Design Review Committee Meeting

April 15, 2020 6:00 PM

PLANNER'S REPORT

TO: Tonya Hutson
FROM: Michael Smith
RE: Mural – 845 North Central Avenue
DATE: March 12, 2020

Side Deck		
Project number	20170209	A107
Date	03/16/2020	
Drawn by	Author	
Checked by	Checker	Scale 1/4" = 1'-0"

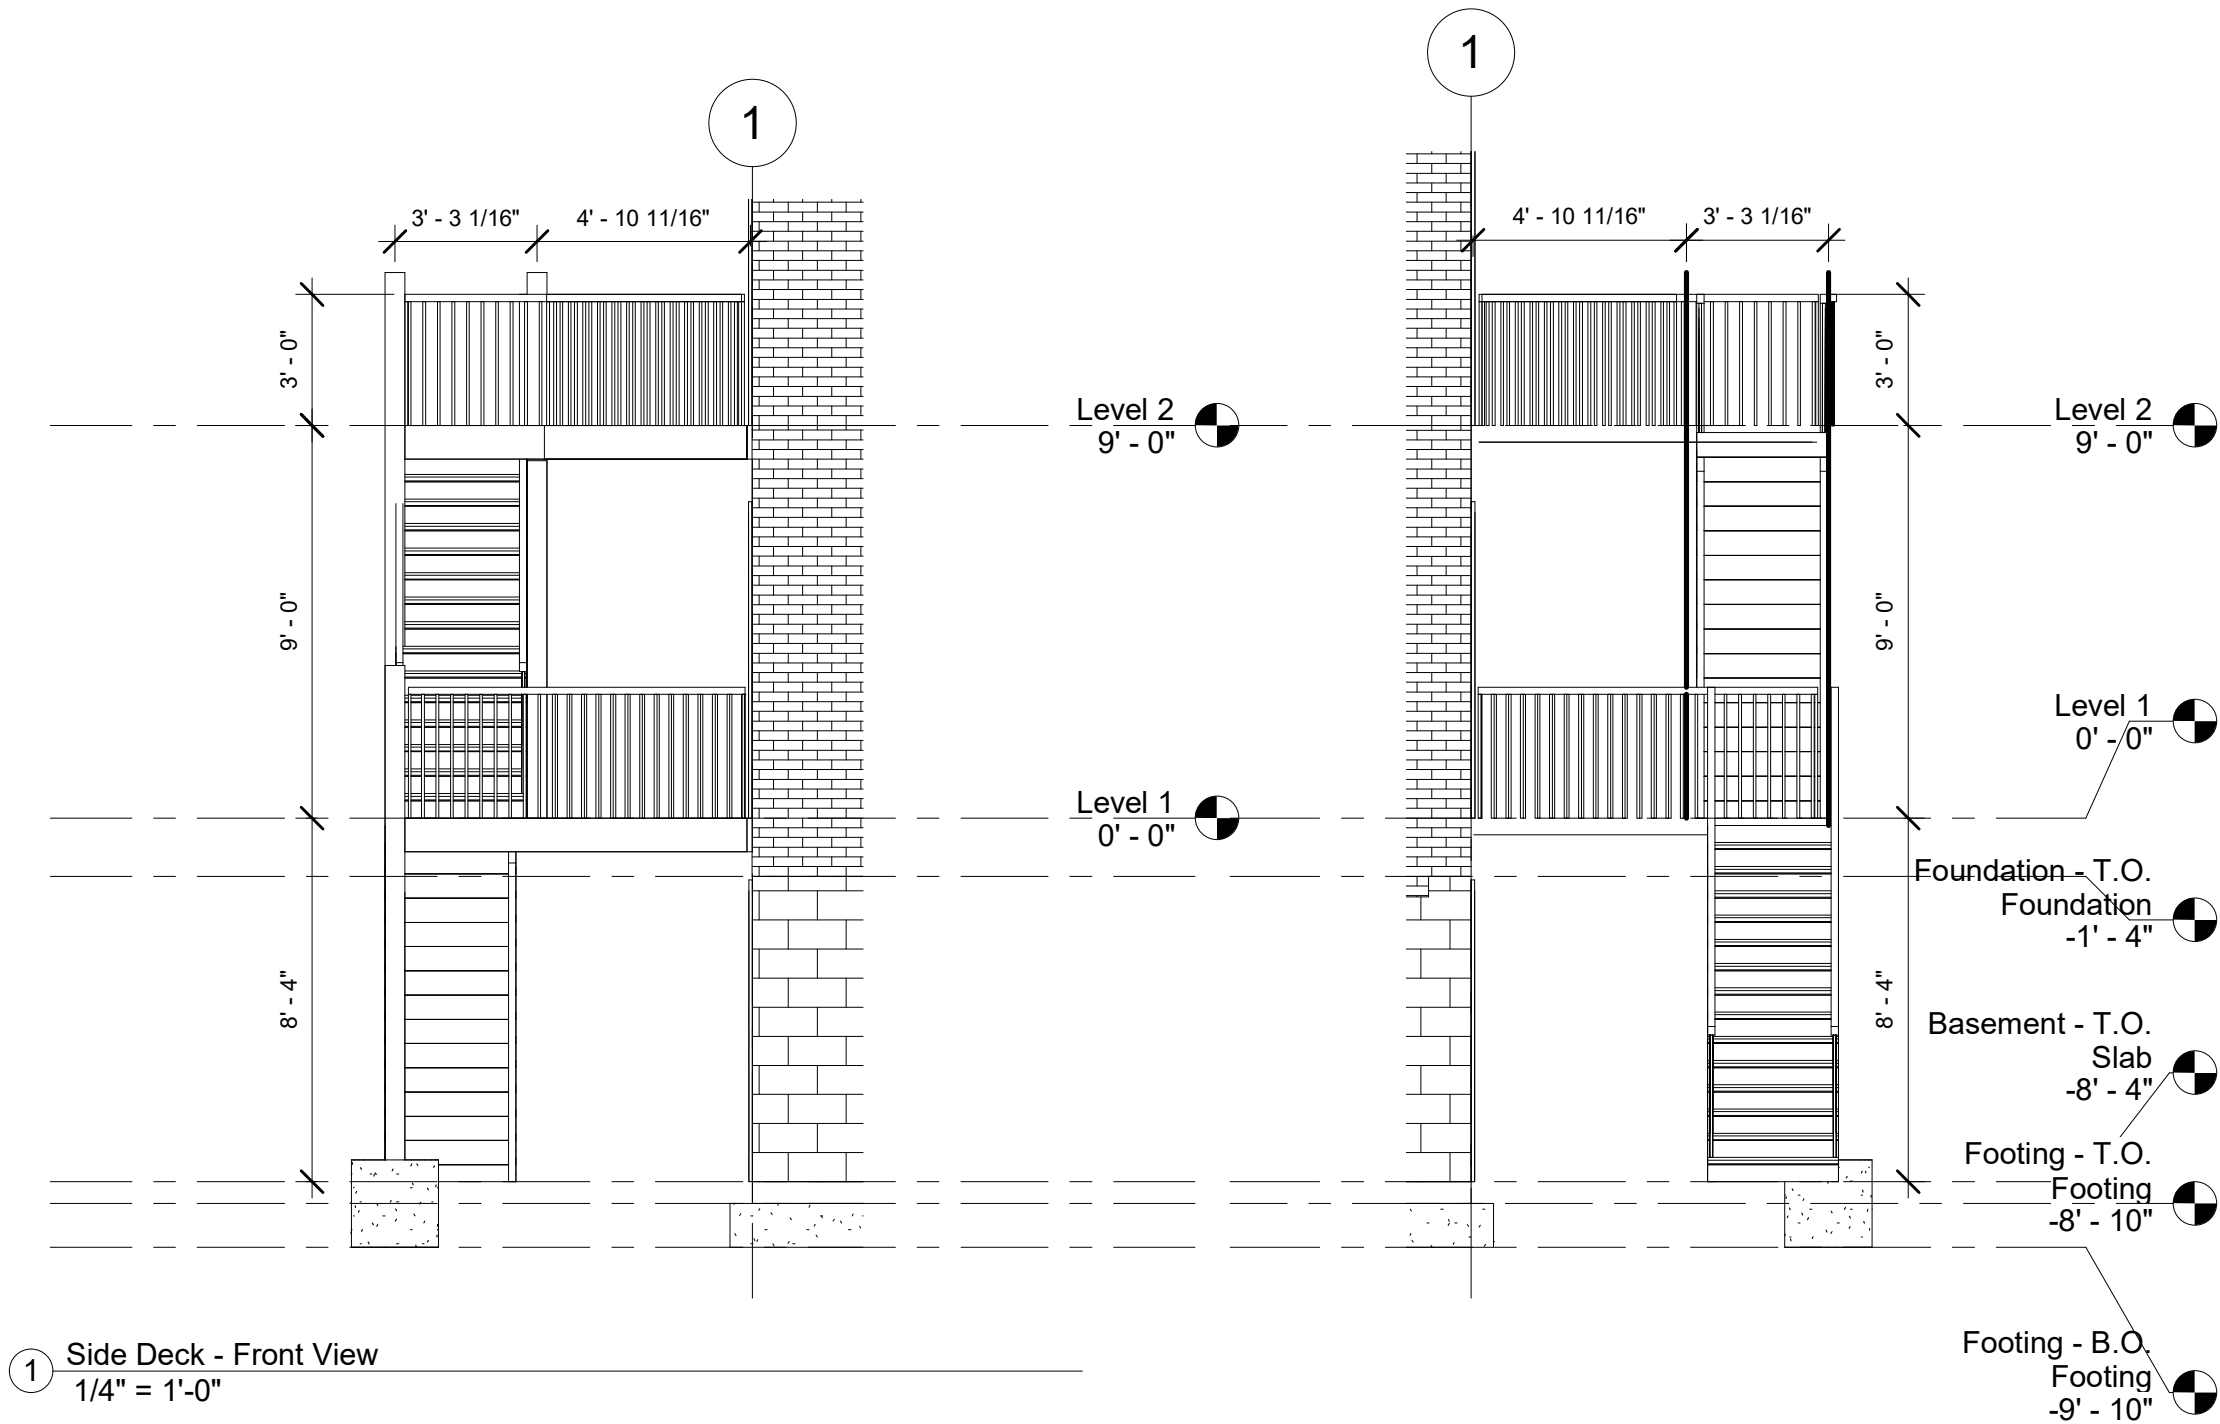
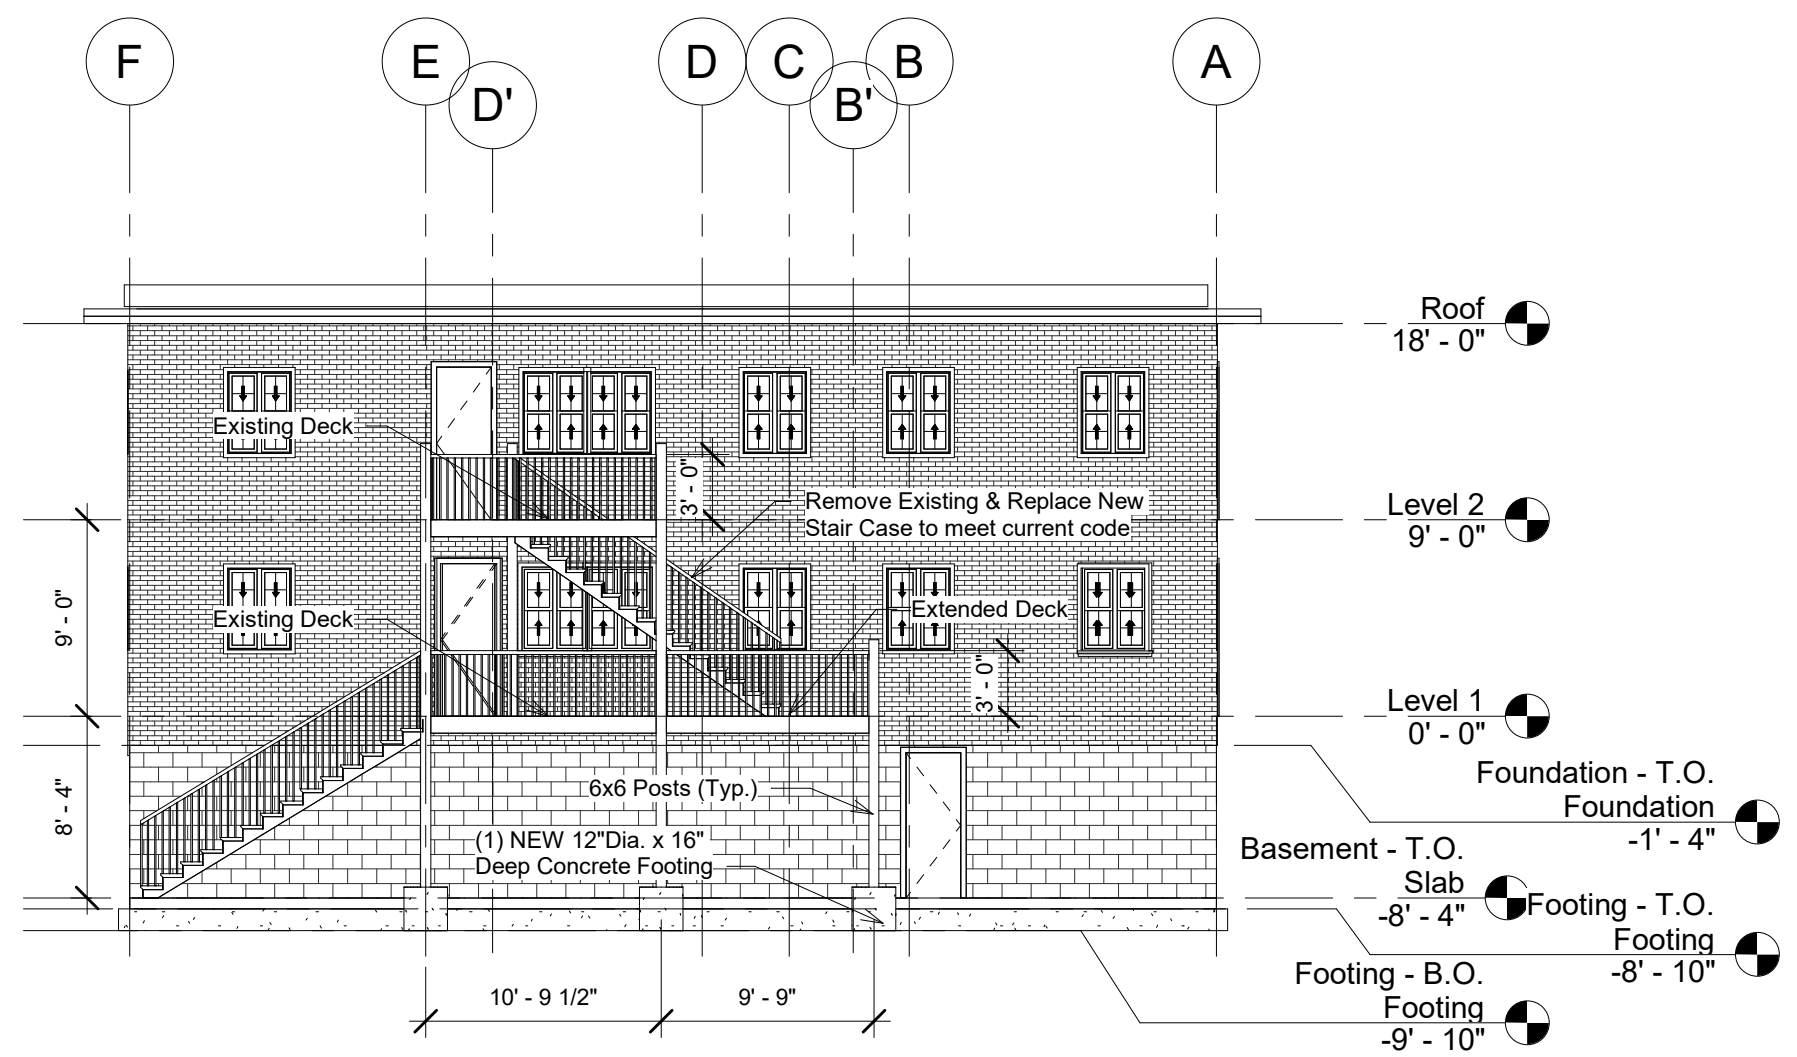
The applicant's request to replace existing windows on the southern side façade with transom-style frosted windows and brick infill is compliant with the Standards. Further, the proposed "deck" is compliant with zoning setback requirements as the RMU zone does not have side setback requirements. However, the design of the deck is beyond the purview of the Sec. 81-1-6 and thus the Design Review Committee must instead make their decision based on the *General purpose* and *Goals* of Sec. 81-1-1 (cited above). As the new deck is a replacement of an existing deck that is to be built according to building code, staff recommends approval.

Drawing No.	A-2.1
Paper Size:	24" x 36"

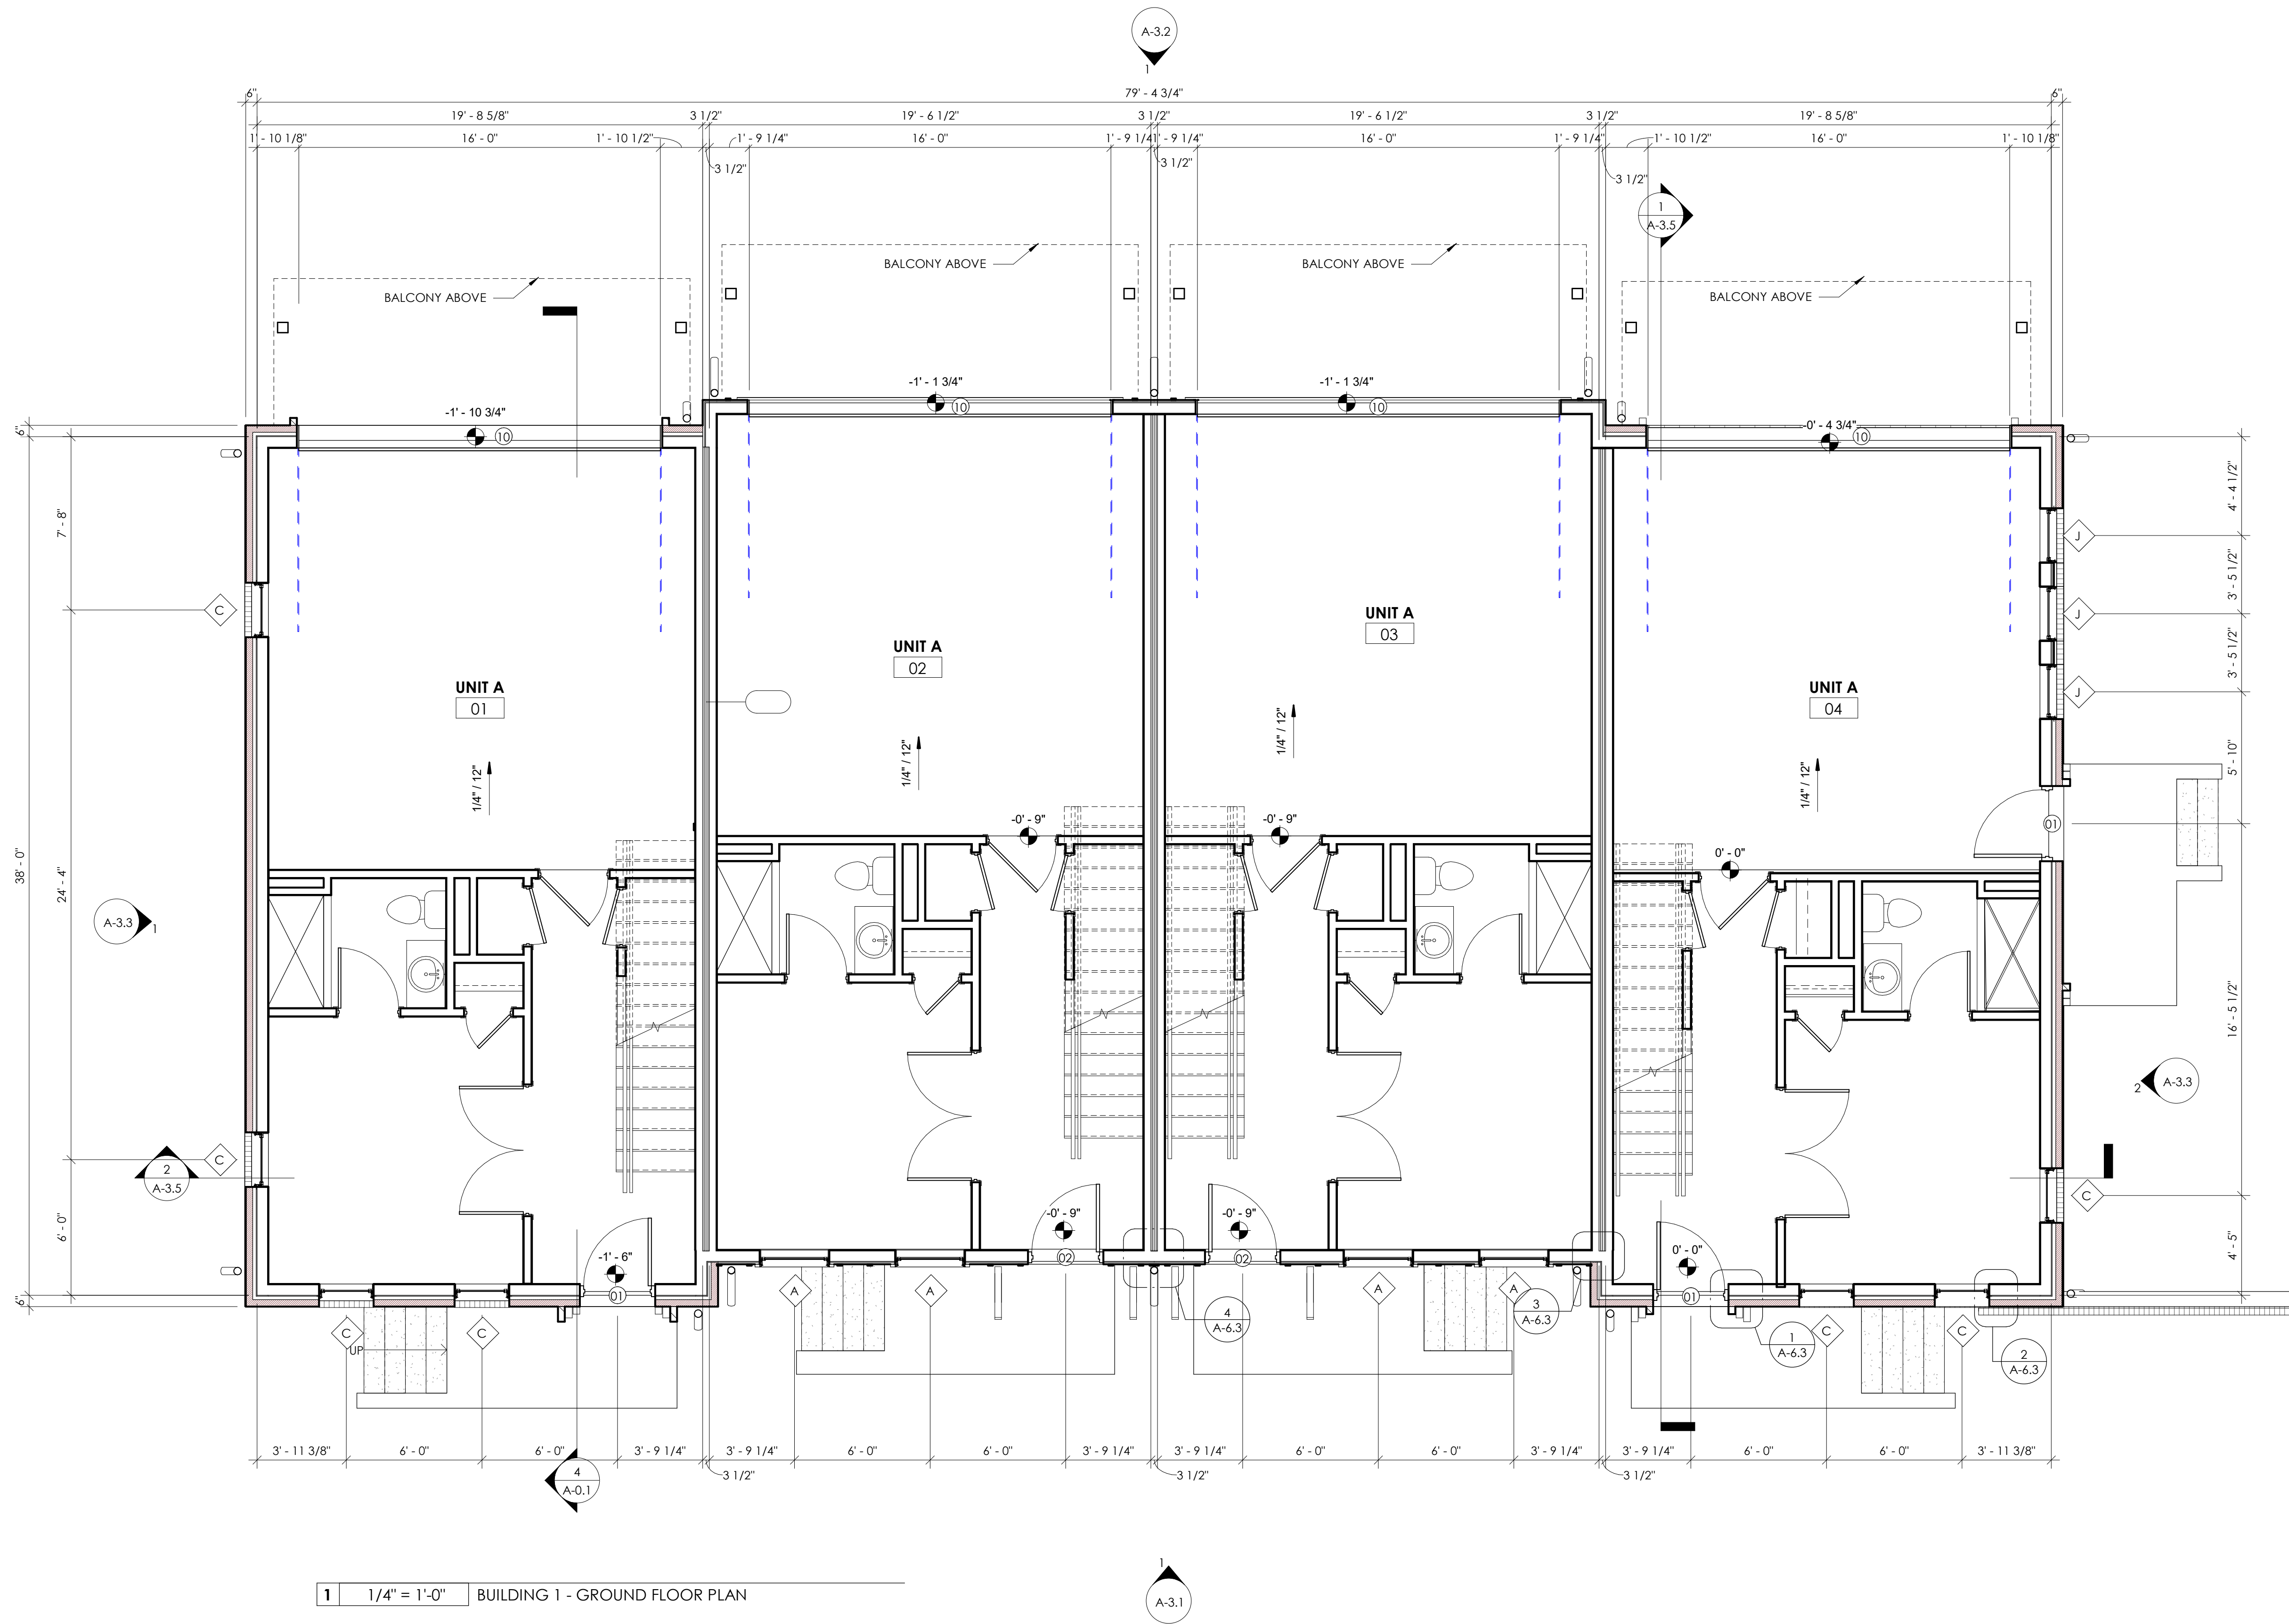
- The building layout has all main entrances facing a share common area rather than the public street, which is not compliant and will require a design exception.
- Building numbers at least 6" in height on the porch or adjacent to the front door should be included and shown on the plans.
- The applicant should provide a window schedule.

- **Windows must comply with all requirements of Sec. 81-1-7(g) - *Door and window standards*. The elevations should be revised to demonstrate compliance and the plans should provide the following information:**
 - **Windowpane recession from adjacent facades (2" recession for frame construction, 3" other construction)**
 - **The width of wooden window trim for wood frame structures (4" minimum) and window mullions between grouped windows (2" wider than side trim)**
 - **Windowsill materials (masonry, wood, stone, cast stone, terra cotta)**
